1318 & 1320 Alki Ave SW, Seattle, WA

# EDG RESPONSE | Priorities & Board Recommendations

North Elevation Window Privacy Study

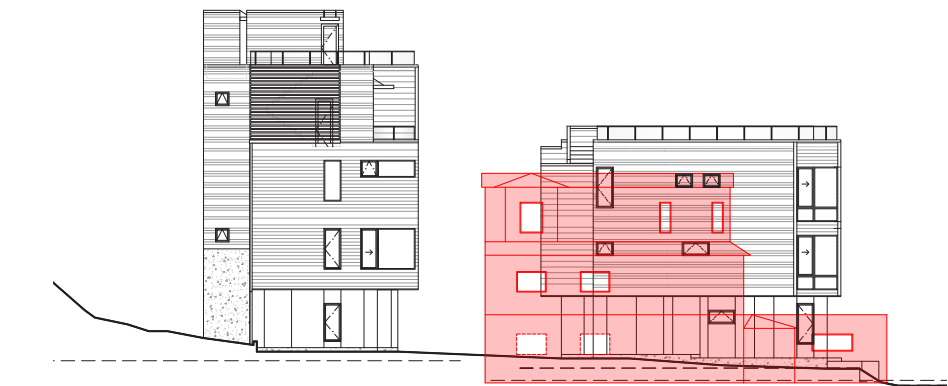
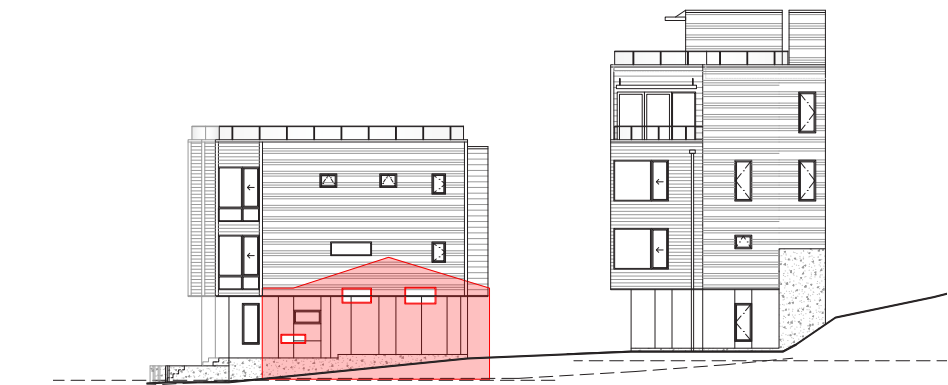
- i. As this new development will be adjacent to existing residential uses, privacy between sites should be addressed. Provide a window privacy study with the properties adjacent to the north and south to illustrate potential impacts on adjacent uses. CS2-D-5. Respect for Adjacent Sites

While the rear structure is now four stories in height this still maintains a relatable scale for the adjacent single-family dwellings and is similar to the proposed massing of the EDG packet which included a mezzanine space in conjunction with rooftop access. It is also likely that adjacent structures will undergo future development with increased height.

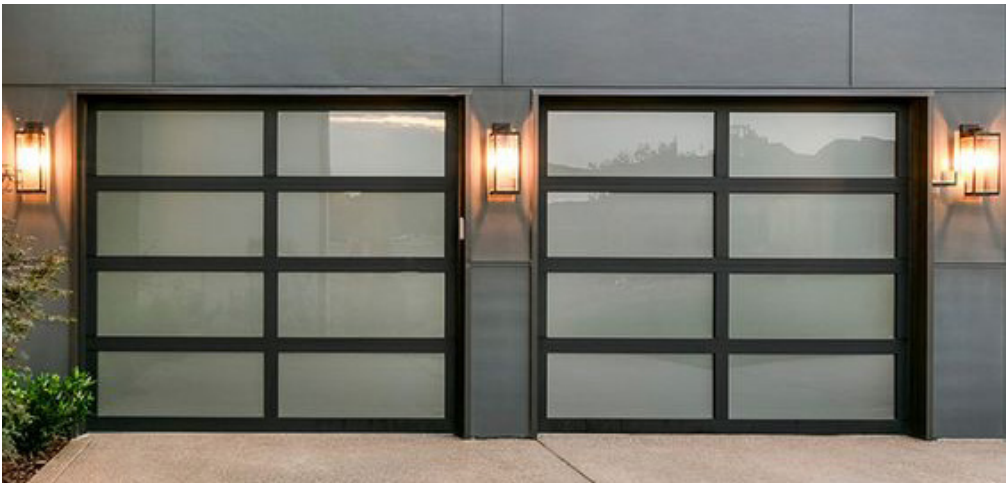
c. Staff supports the use of a high level of glazing both to provide access to the views from the unit interiors and to activate the unit frontages. Glazing should be detailed to add scale and interest to the façade design. DC1-A-4. Views and Connections, DC2-C-1. Visual Depth and Interest

d. Staff supports the use of railings, or other visually permeable

guardrails, at the roof deck, as shown in several of the precedent images. Design of railing and parapets should enhance the façade design, reduce perceived mass of the structures as viewed from the street, and to provide access to views and air flow on the roof decks. DC1-A-4. Views and Connections, DC2-A-2. Reducing Perceived Mass

Significant glazing is provided at all levels of the street facing façade.

All decks are provided with clear glass guardrails with metal top cap and rails. This reduces perceived massing, allows for better views from roof decks and improves views for rear units.

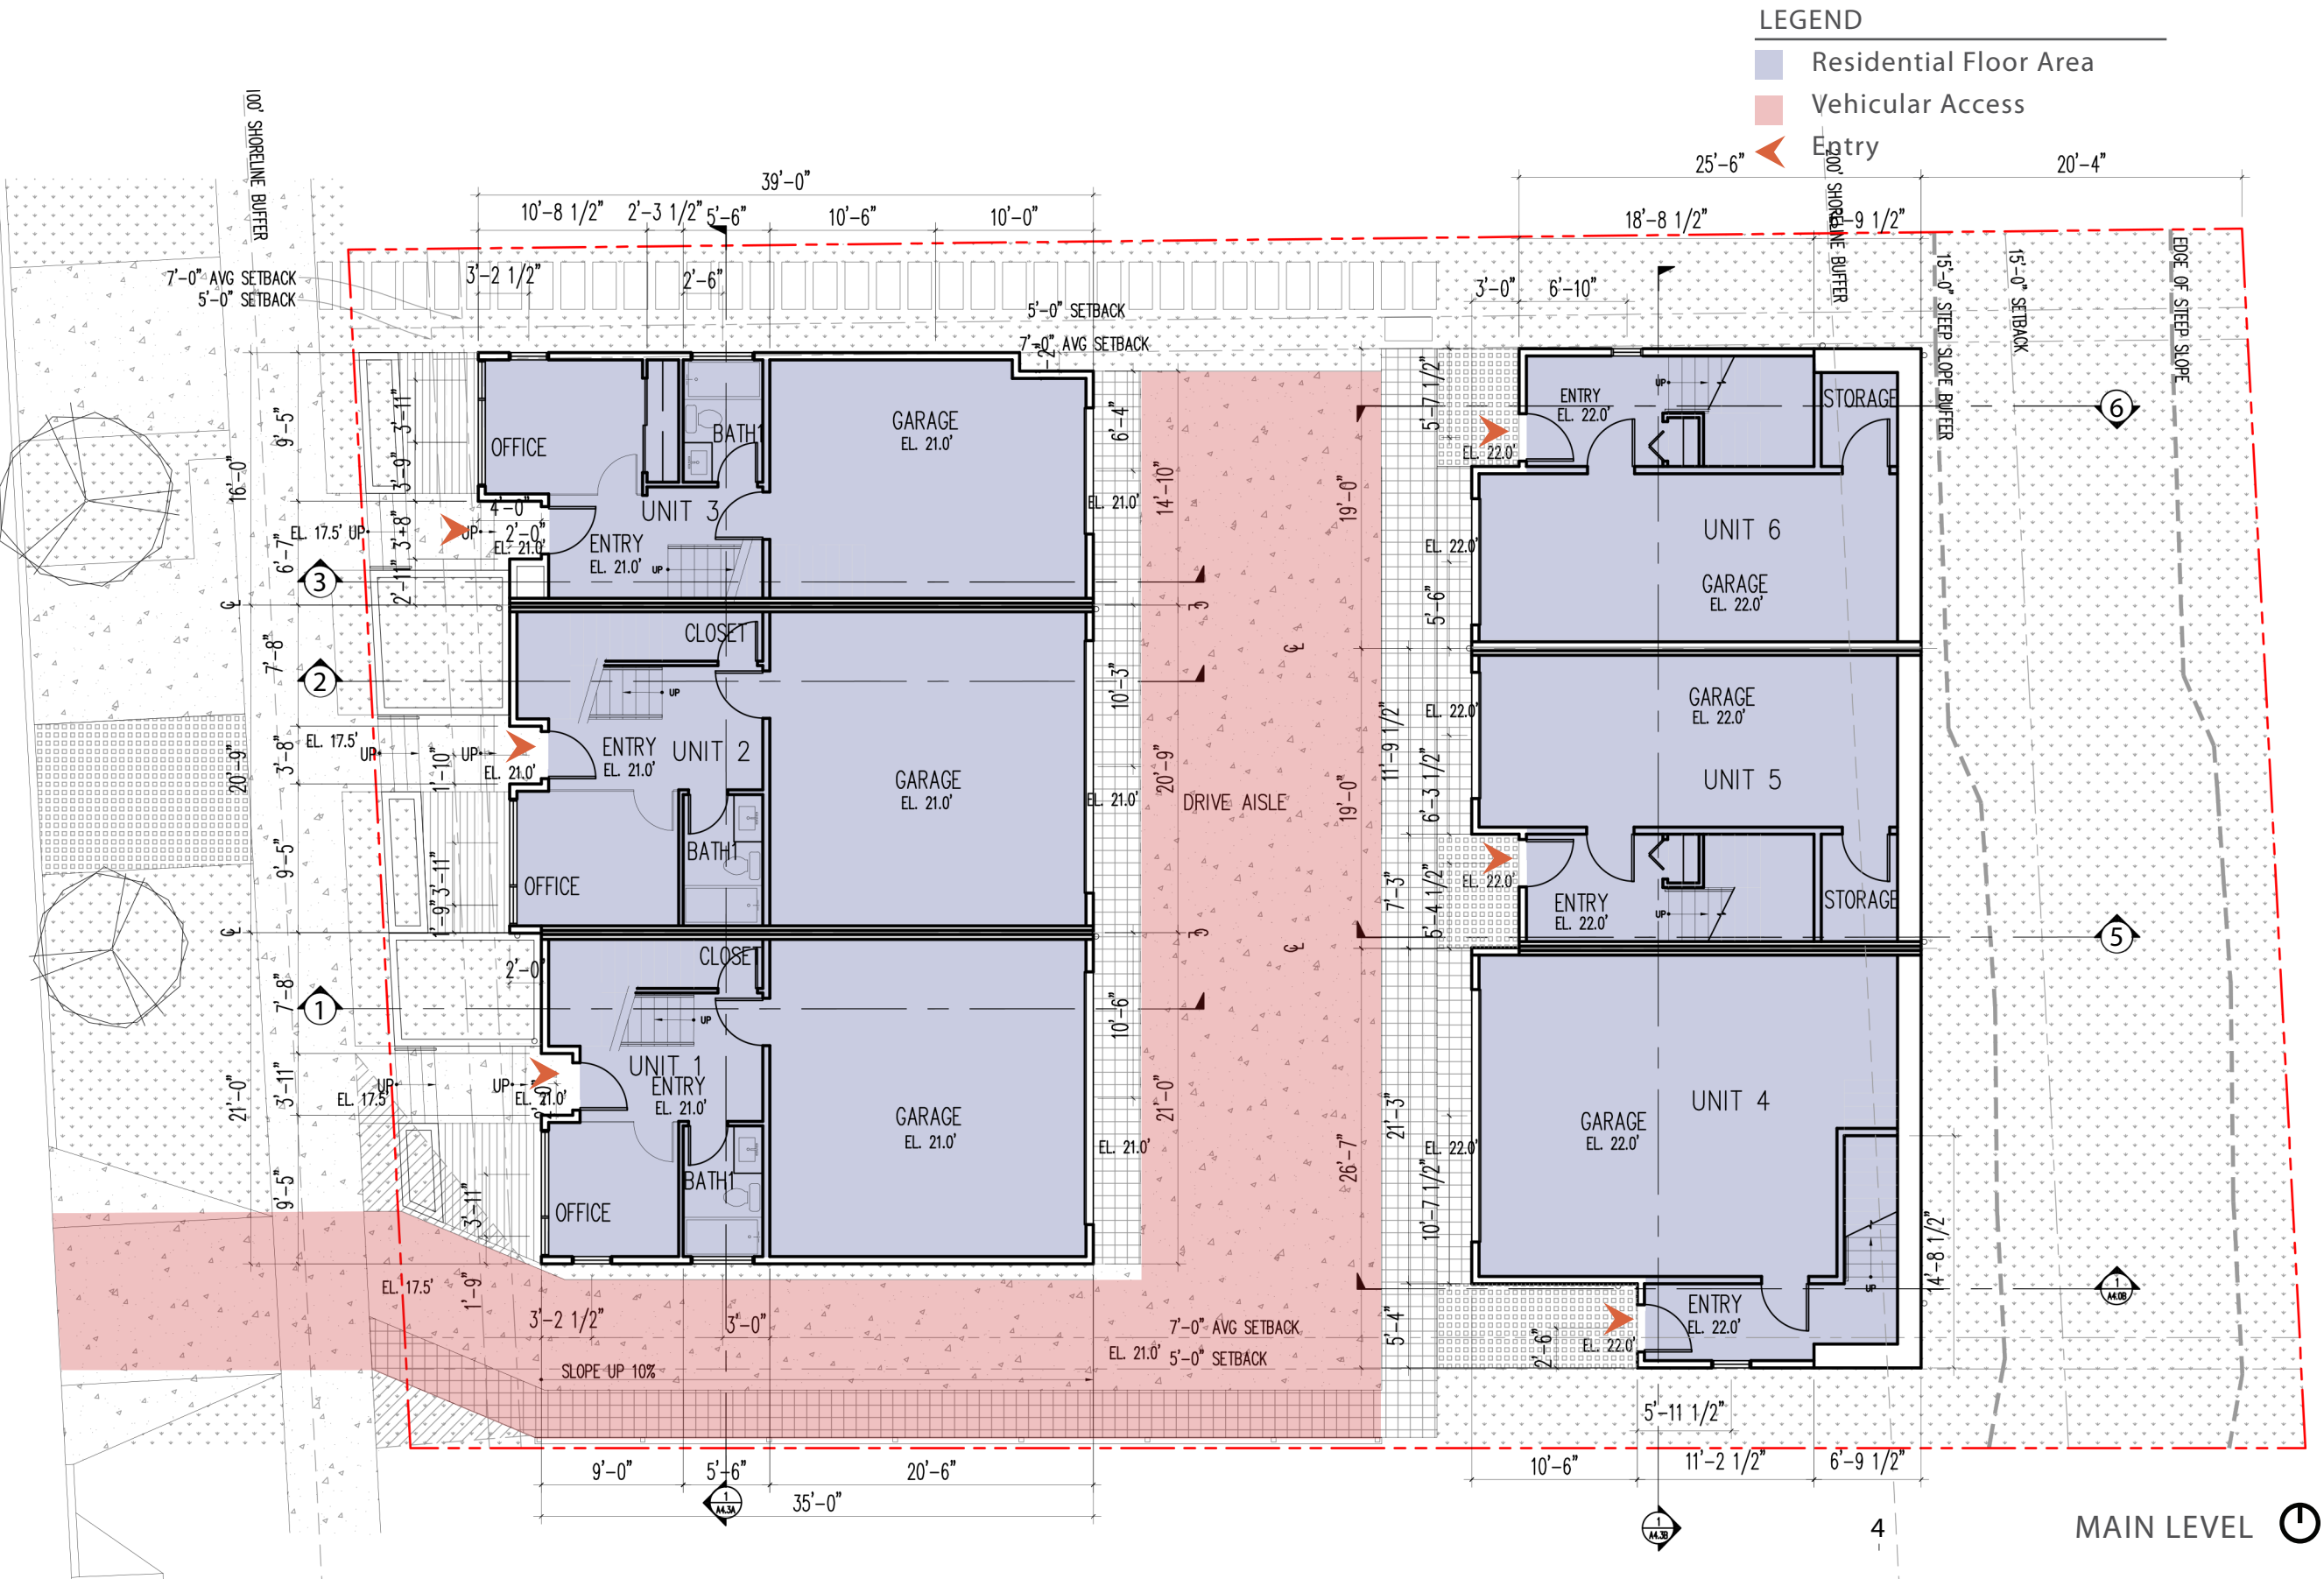
e. Staff does not support the location of solid waste storage shown in Option 1 layout. Locate the storage area against a fence or the blank wall of a garage so that required screening does not block views through the site. Show individual bins to clarify adequate space for solid waste storage is provided. Show planned staging locations for bins in the right-of way. DC1-C-4. Service Uses

f. Staff supports locating short term bike parking in the planting strip in the right-of way. Ensure all long-term bike parking is indicated in future plan submittals. PL4-B Planning Ahead for Bicyclists

The storage area has been pushed closer to the north property line with removal of the north sidewalk. Additionally the number of cans within the enclosure has been minimized as others fit within individual garages. Solid Waste screening at +/-48” will not impede visual access through the drive court. Staging location is indicated within the right-of-way.

Site plan indicates short-term bike parking located within the right-of-way.
